Access Compliance Report Public Rights-of-Way (Curb Ramps)

Main Street: **MERCANTILE_WAY** Cross Street: **THIRD_RD** Location: **SE**

ADA ID: **RPRK211029123830** Ramp Type: **Type 1 - Perpendicular** Initial Pass/Fail: **Pass** Overall Compliance: **No** Severity Score: **16**

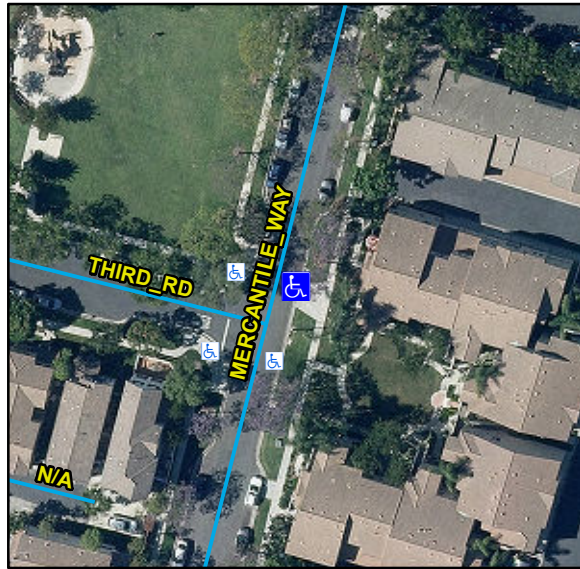
Compliance	Description	Data	Compliance	Description	Data
N/A	Ramp Length (in)	150	N/A	Flare Type LT	
Yes	Ramp Width (in)	48			Sloped
Yes	Ramp Run Slope (%)	7	N/A	Flare Slope LT (%)	13
Yes	Ramp Cross Slope (%)	0.4	N/A	Flare Traversable LT	No
N/A	Landing Present	Yes	N/A	Flare Type RT	
N/A	Landing Length (in)	48			Sloped
Yes	Landing Width (in)	48	N/A	Flare Slope RT (%)	12.1
No	Landing Run Slope (%)	3.4	N/A	Flare Traversable RT	No
Yes	Landing Cross Slope (%)	1.7	No	DWS Provided	No
N/A	Landing Movement Obstructed?	No	N/A	DWS Contrast	N/A
	Landing Movement Type	N/A	N/A	DWS Length (in)	N/A
N/A	Landing Shared	Yes	N/A	DWS Full Width	N/A
N/A	Clear Space	N/A	N/A	DWS Offset Left (in)	N/A
N/A	Clear Space To Crosswalk (in)	N/A	N/A	DWS Offset Right (in)	N/A
N/A	Marked Crosswalk 1	No	N/A	Marked Crosswalk 2	N/A
	Crossing 1 Direction	NW		Crossing 2 Direction	N/A
	Marked Crosswalk 1 Width (in)	N/A		Marked Crosswalk 2 Width (in)	N/A

N/A	Ramp Inside Crosswalk 1	N/A	Yes	Ramp Inside Crosswalk 2	N/A
	Crossing 1 Slope (%)	0.4		Crossing 2 Slope (%)	N/A
	Crossing 1 Cross Slope (%)	2.5		Crossing 2 Cross Slope (%)	N/A
Yes	Gutter Ponding	No	No	Curb Slope	7.3
Yes	Gutter Lip Height (in)	0		Road Run Slope (%)	N/A
No	Gutter Run Slope (%)	8.6		Road Cross Slope (%)	N/A
Yes	Gutter Cross Slope (%)	0.9			
Yes	Overall Surface Condition: Acceptable		No	Perp Joint Present	No
	Cross Gutter Present?	No		Spandrel Present?	No
	Replace Cross Gutter?	N/A		Replace Spandrel?	N/A

Remove & Replace Entire Ramp. Remove & Replace Gutter.
